## Work Changes Proposal Request

THE FIELD SCHOOL:  
ADDITIONS AND  
RENOVATIONS

**PROPOSAL REQUEST NUMBER:**

035

FIELD SCHOOL  
CQTS ARCHITECTS  
CROSS SLOPE WALL.  
SK 12.03.03.003  
SCALE 1/2" = 1'-0"

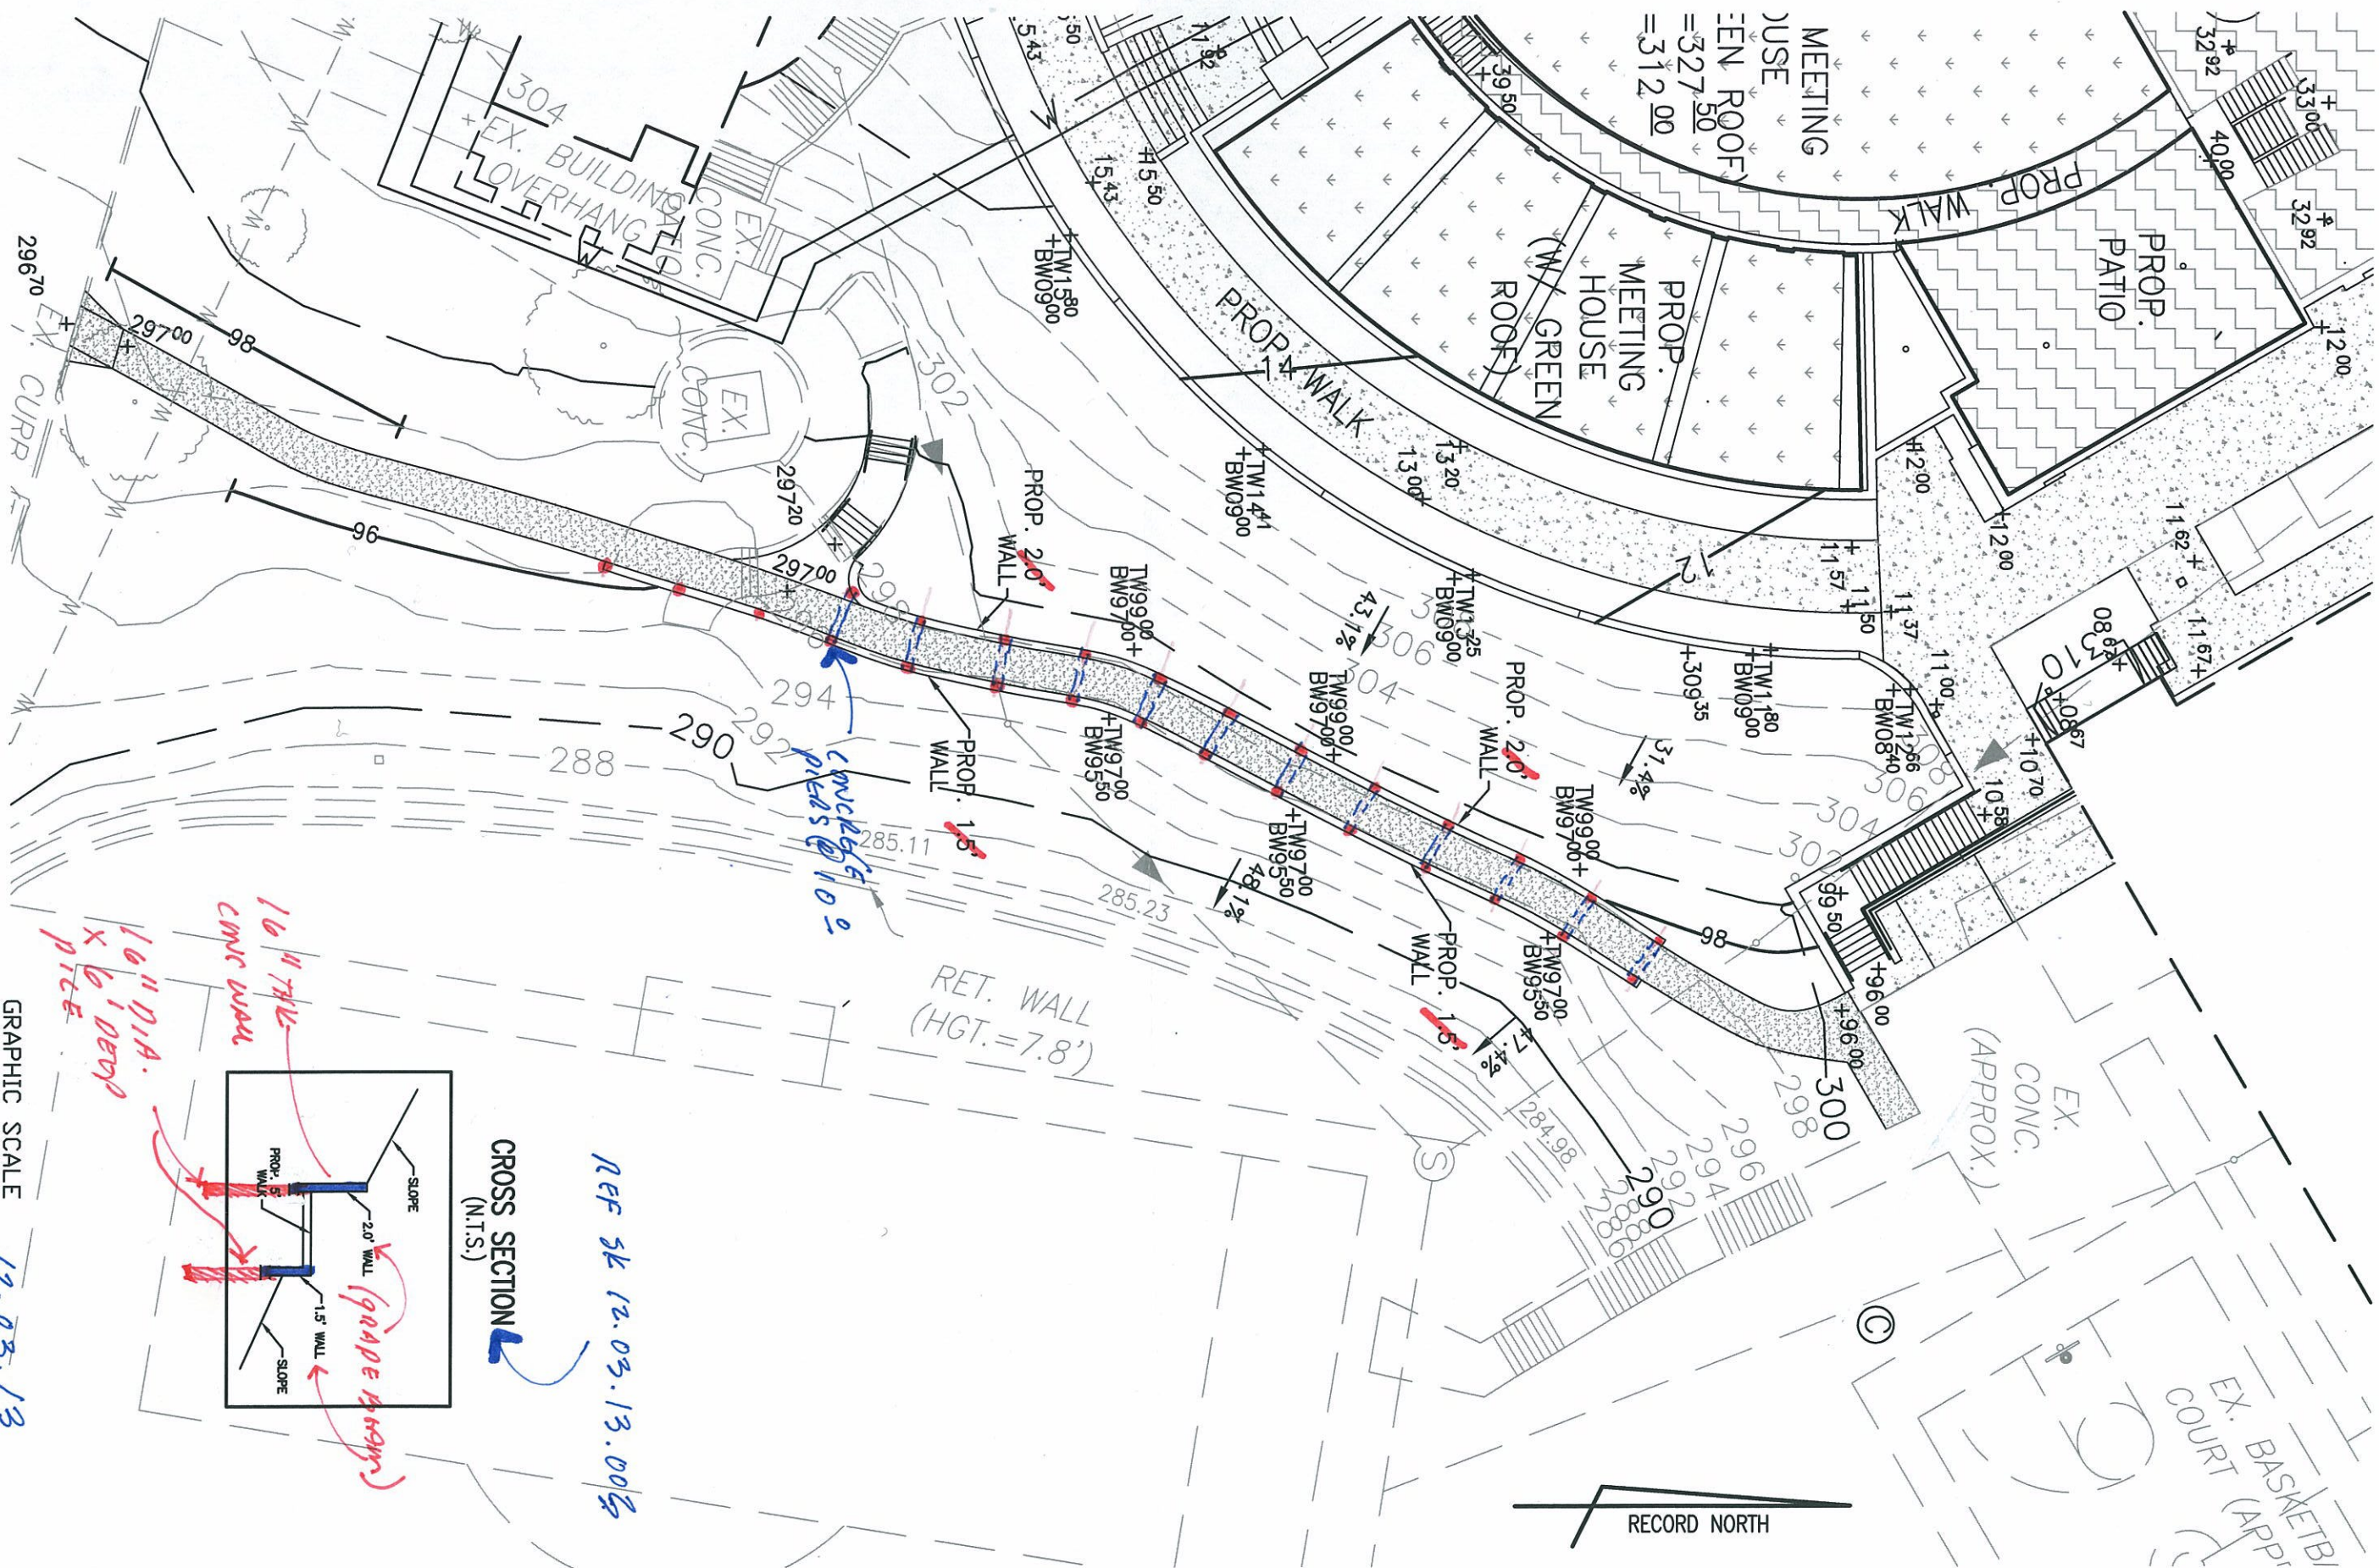
Provide pricing to install a cross slope path and walls per the attached sketches.  
Reference RFI 157
